ENVIRONMENTAL COMMISSION MOTION 20221102-002

Subject: Brodie Oaks Redevelopment PUD, C814-2021-0099

NAME & NUMBER OF PROJECT: Brodie Oaks Redevelopment PUD C814-2021-0099

Brodie Oaks Redevelopment PUD

Exhibit F: Environment

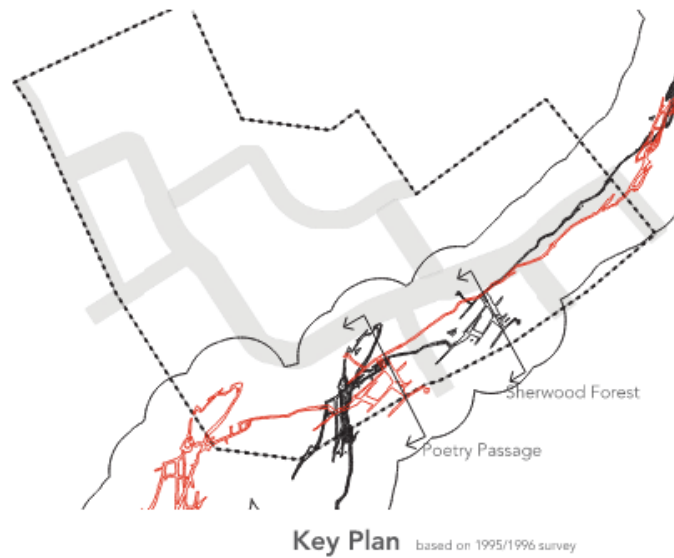
1. Modify CEF setback for S-1/S-2
2. Impact to Airman's Cave CEF setback is limited of up to 80' with conditions
3. Protective fencing for CEFs
